ADDENDUM NO. 1

**REBID: Replace Floor & Equipment, Food Service Building
Ozark Correctional Center
Fordland, Missouri
Project No.: C2237-01**

REPLACEMENT OF FLOOR
AND FOOD SERVICE
EQUIPMENT

SHEET TITLE:
**KETTLE PAN
FLOORPLAN
REVISION**

ADD-01

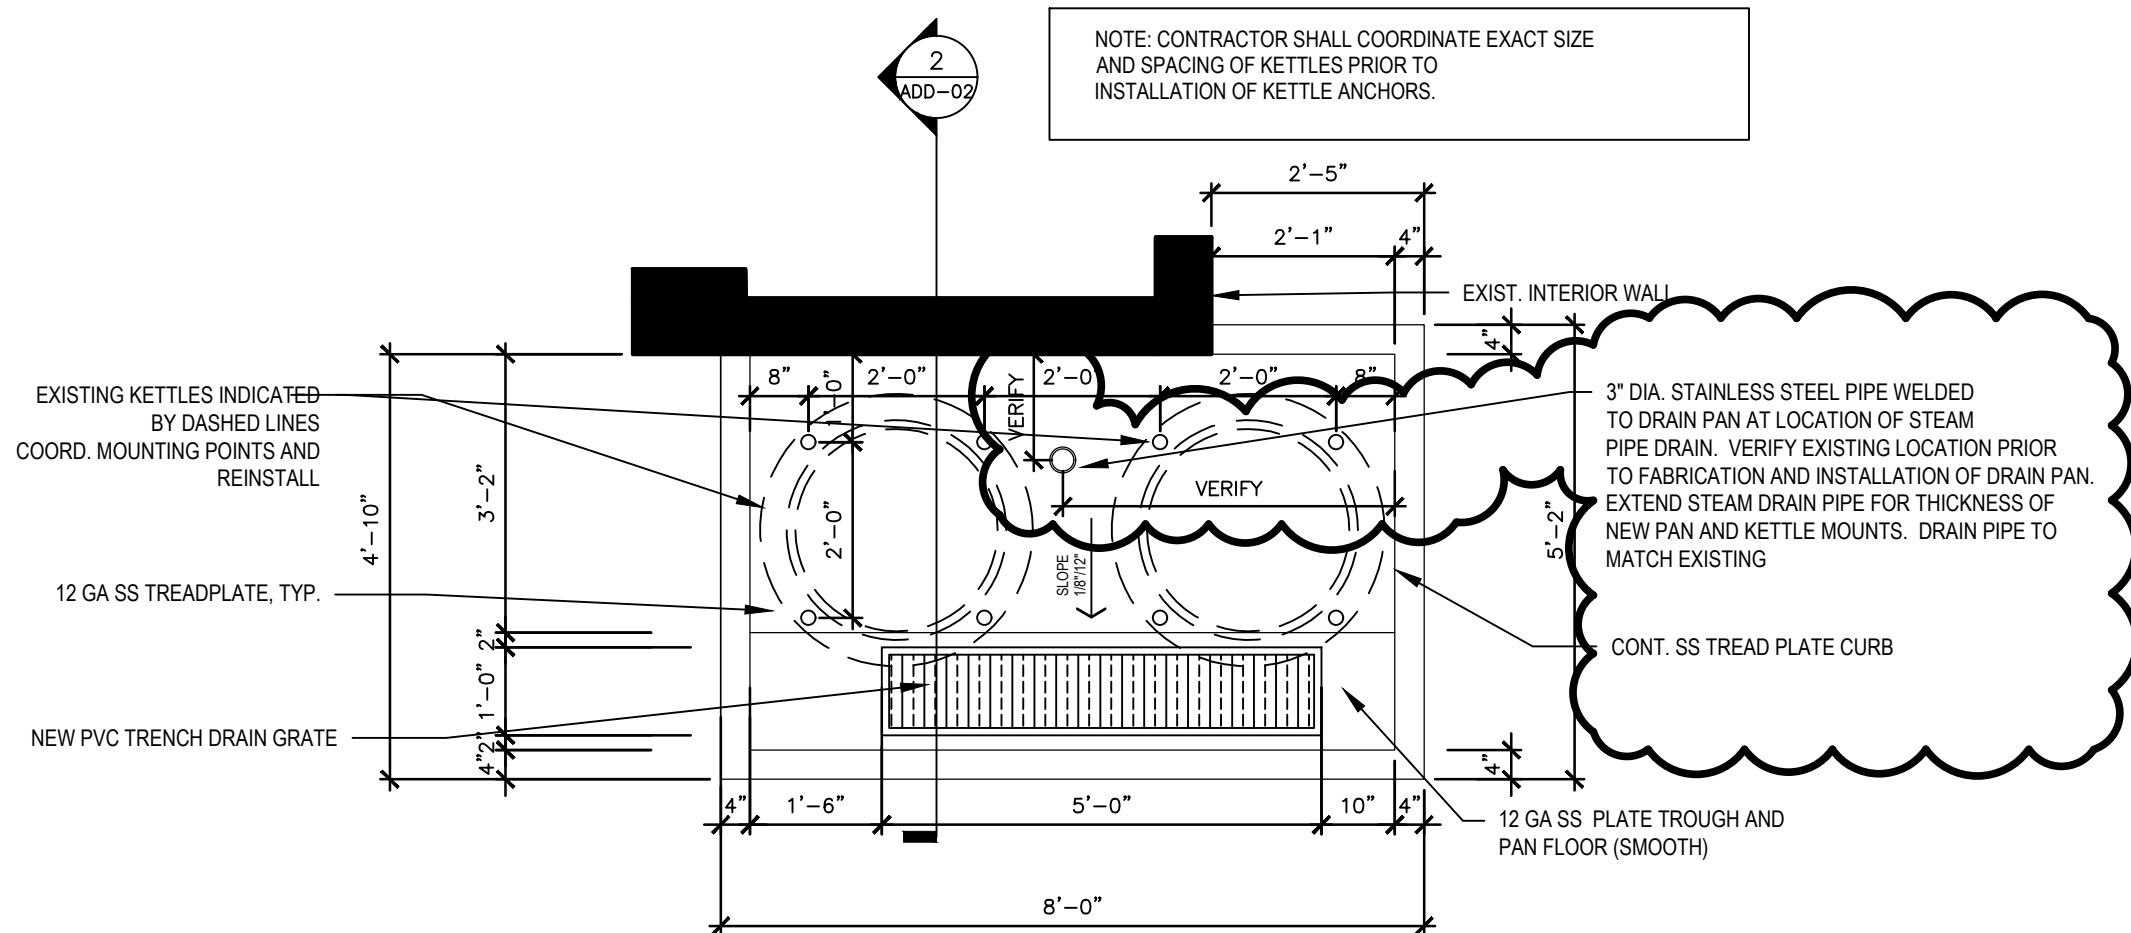
1. Sheet A-501

- a. ADD the following Note to Details 1 and 2:
“3" DIA. STAINLESS STEEL PIPE WELDED TO DRAIN PAN AT LOCATION OF STEAM PIPE DRAIN. VERIFY EXISTING LOCATION PRIOR TO FABRICATION AND INSTALLATION OF DRAIN PAN. EXTEND STEAM DRAIN PIPE FOR THICKNESS OF NEW PAN AND KETTLE MOUNTS. DRAIN PIPE TO MATCH EXISTING”

Refer to attachments ADD-01 and ADD-02 for revised Details 1 and 2.
